TAB Punchlist

Oct 2, 2024

L04810_Expressway Plaza FSU

#90 [UNIT 504] [NEW] Equipment Fresh Air Tempering.

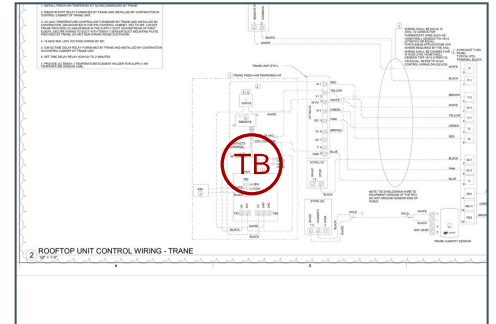
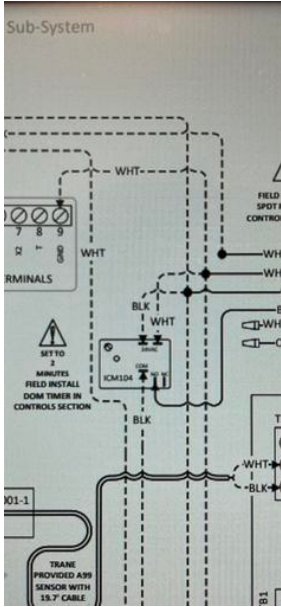
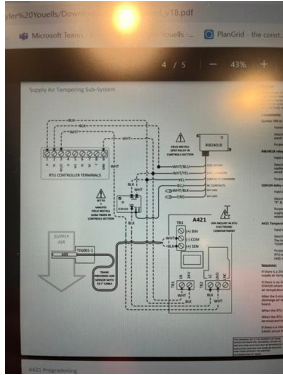
FAT Tempering kits are not functioning properly. The wiring was installed per the Trane drawings provided which also does not match the MSET. When rewired to the MSET drawings the FAT kit still does not work. Per TRANE/SEC MC needs to adapt the kit per the new unreleased spec attached. the new spec requires a different style timer and a few wiring changes.

#89 [EXHA 509] [NEW] Grease exhaust duct is not painted.

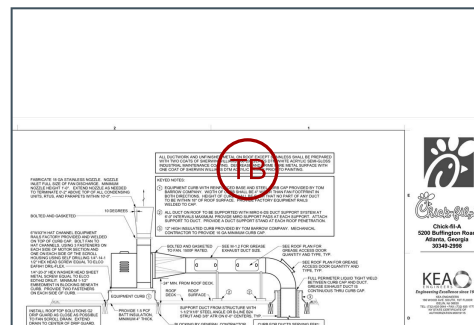
Description
After changes to grease duct repaint/paint ductwork. Exposed grease exhaust duct is to be painted per specification on kitchen hood exhaust fan detail.

#12 [UNIT 514] [NEW] Equipment gas piping.

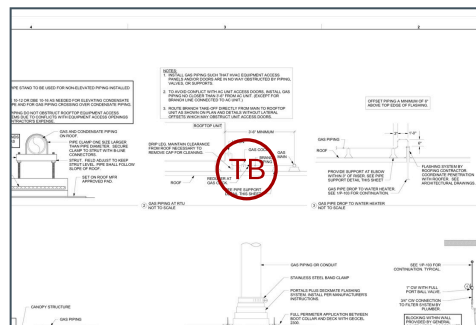
Equipment missing gas grommet, gas startups incomplete, or gas piping is not constructed/supported per normal CFA specifications (incorrect drip leg/missing inverted trap/flex piping connections). Confirm with CFA CM that current installation is acceptable. Typically a reducer occurs pre gas cock. Typical install shown in pics.

#11 [UNIT 517] [NEW] Condensate piping construction.

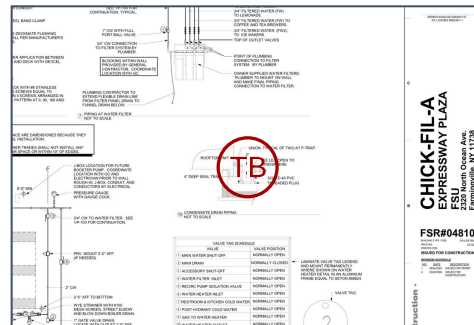
Description
 Equipment condensate piping or p-trap is not constructed per normal CFA specifications. Trap does not have a 2" deep seal and open T vent is not cut below outlet of the unit. Correct all ac unit traps.
